Snubber causing more problems than benefits

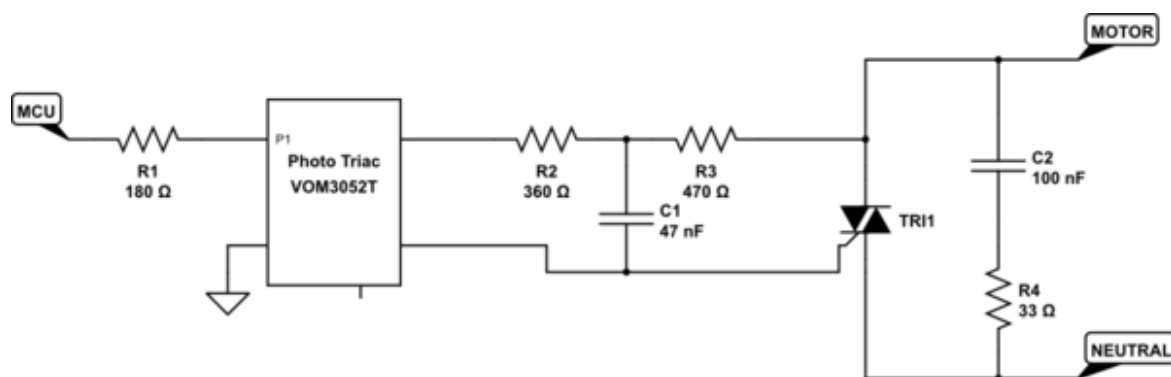
When designing and building a simple motor controller i used 2 snubber circuits, one to protect the main triac and another one the smooth the communication between the phototriac and the main triac. See schematic below.

When testing the circuit however, no matter if the Microcontroller's pin is high or low, the motor always turns on. I found that when removing C1 the problem did not occur and the circuit perform as it originally was supposed to do.

The questions is: Is removing C1 from the circuit a viable option, or will this cause the circuit to fail in

the long run? why does the circuit not work when C1 is placed?

C1 is definitely the cause why the TRIAC fires. Why did you implement it? Where did you find the circuit diagram? – [jippie](#) Aug 24 '14 at 18:54

For an average TRIAC 1.5mA is sufficient gate current to trigger it and the photo-TRIAC has no part in it at all. When using a 230V mains, the current will even peak at approximately 5mA. As Wouter mentions in his answer aswell, the current calculated is shifted in phase with respect to the voltage across the TRIAC, causing the TRIAC to reliably trigger.

I am unsure why C1 was included in the circuit. The TRIAC doesn't act as an inductive or capacitive load, so there is little need for a snubber around C1 anyway. The other snubber C2/R4 can be much more beneficial, although a snubber should ideally be dimensioned for a specific load.

I don't know where you got that circuit(r2,r3,c1), but IMO it is rubbish.

Think of what happens when the foto-triac is not conductiong. In effect you can remove it and R2 from the circuit. Now you have the gate of your triac triggered via R3/C1, which delivers a phase-shifted current through the gate, 'conveniently' non-zero when the triac voltage is zero, thus switching the triac on after each zero-crossing, eactly as you observe.

The function of a snubber circuit is to suppress rapid voltage transients, which would otherwise cause the triac to start conduction. But at the same time the snubber circuit should not conduct so much current that it causes the load to be switched on. The trouble with your 'snubber' for the foto triac is that it conducts so much current that it always triggers the triac.

Yes connecting it to neutral will work too. It'll introduce a slight phase shift for the current through the photo-TRIAC, which may improve triggering of the main TRIAC. – [jippie](#) Aug 24 '14 at 22:00

$$X_C = \frac{1}{2\pi fC} = \frac{1}{2\pi \cdot 50 \cdot 47 \cdot 10^{-9}} \approx 68k\Omega$$

$$I = \frac{U}{X} = \frac{100}{68k} \approx 1.5mA$$

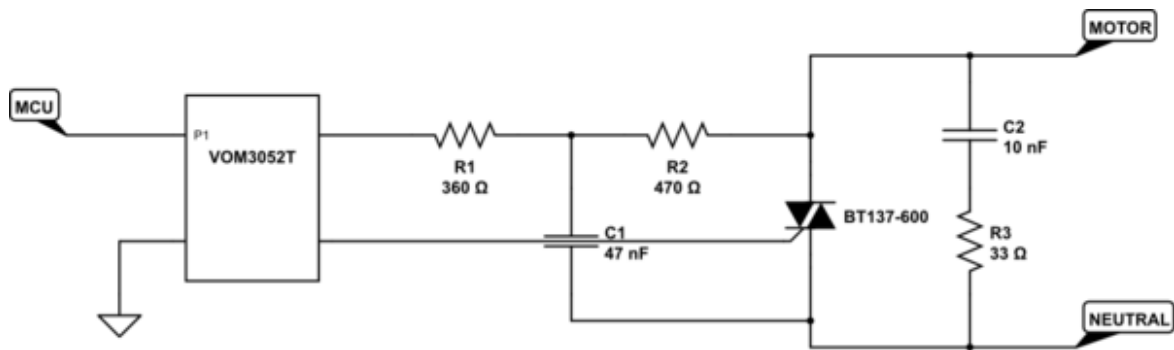
now that C1 is removed, the phototriac does not have a snubber anymore, but seems to work fine
